# ENTSO-E European Resource Adequacy Assessment 2021 consultation

A Eurelectric response paper

## Annex : National assessment ENTSO-E ERAA 2021

[FIGURE 6-1] — NEW CAPACITY REQUIRED IN THE 'CENTRAL' SCENARIO FOR BELGIUM TO MEET THE RELIABILITY STANDARD OVER THE COMING 10 YEARS

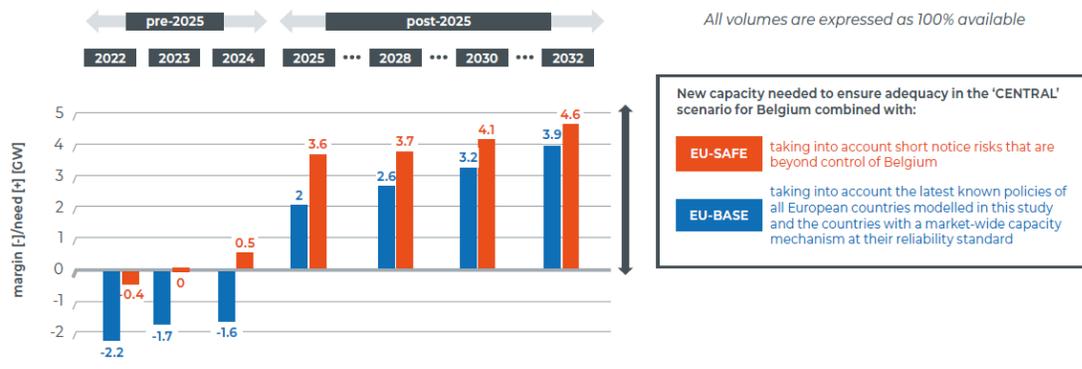
In this scenario, the structural need for new capacity in Belgium amounts to 3,6 GW in 2025 and gradually increases to reach 4,6 GW by 2032. Given that we observe structurally an even more important unavailability of foreign firm dispatchable assets than recommended to be considered by Elia, the GAP value is likely to increase at the 2025 horizon.

**Generation:** has the additional closure announcements been considered? (cf. Vilvoorde power plant and Seraing ST).

**Demand:** post Covid recovery and boost of electrification policies being put in place in Belgium is likely to increase the total demand & average peak demand; the electrification trends used in the ERAA are dated from end 2019: this is no longer up-to-date and does not integrate new policy announcements (cf. boost of EVs in Flanders and decision to make the large company cars' fleet greener).

**RES:** ambitions of the NECP (2019) are high; the start of the commercial operation of the second wind offshore zone is likely to be delayed compared to initial planning in 2026 (delay also expected in the infrastructure works). We also observe important NIMBY effects for wind onshore projects, putting the ambitions at risk (context especially difficult in Wallonia). Overall, the RES potential in Belgium is limited.

**Demand Response:** ambitions are also excessively high; we observe important participation of demand response in the last CRM auction for 2025-26 (around 350 MW derated -> low hanging fruit) but still far from the expectations of Elia and national authorities; the roll-out of smart meters will be key to unlock demand response at residential/SME level while the different regions have different paces. It is clear that Belgium has always been a front-runner in the development of demand response; however, the ambitions of Belgium are high compared to neighbouring countries.

**Storage capacity:** potential is also ambitious; due to improved conditions for future CRM auctions (better contribution to SoS via the derating factor), it's likely to attract new projects; but for the moment, only 40 MW of batteries have been contracted for the CRM year 2025-26 while the ambition was set initially around 1GW. V2G: the roll-out also depends on the technology to make EVs active market participants in the electricity market as well as the behaviour of the consumers.

**Offshore:** we assume that the most realistic scenario is to reach 3 GW by 2028 and 4,4 GW by 2030. To reach 4,4 GW major investments in grid infrastructure are required, which have still not begun, so there is a lot of uncertainty related to the feasibility of the deadlines.

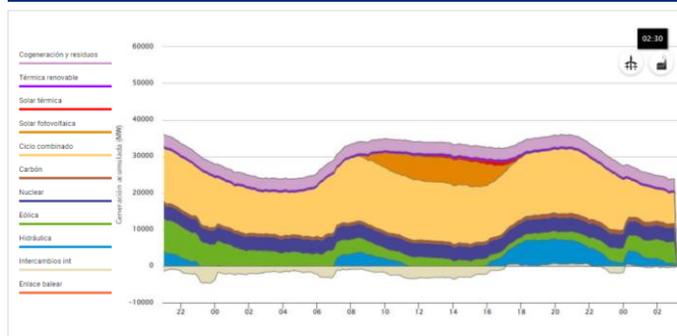
- It is unrealistic the consideration of 2,000 MW coal generation in 2025, since the closure of all coal units (except Aboño 900 MW) has already been approved. At the end of 2021 there are only 4,890 MW of active coal plants.

and PGR has already applied for the decommissioning authorization, which should be awarded in early 2022. By 2025, coal capacity in Spain will be just 877 MW (Aboño 1 and 2) and not even that, since this power plant is expected to be retrofitted to burn steel gas reducing their capacity to 200 MW.

Electricity generation (MWh) to cover demand on the 30<sup>th</sup> November 2021

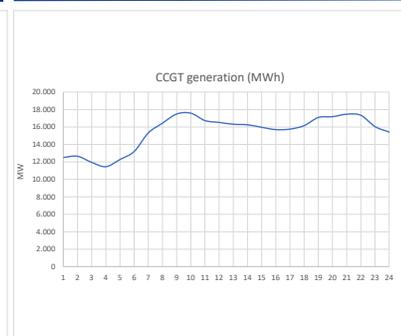
In case Spain does not achieve the ERAA National Estimates for Spain in 2025, there is a serious risk of security of supply if 14,643 MW of CCGT are decommissioned
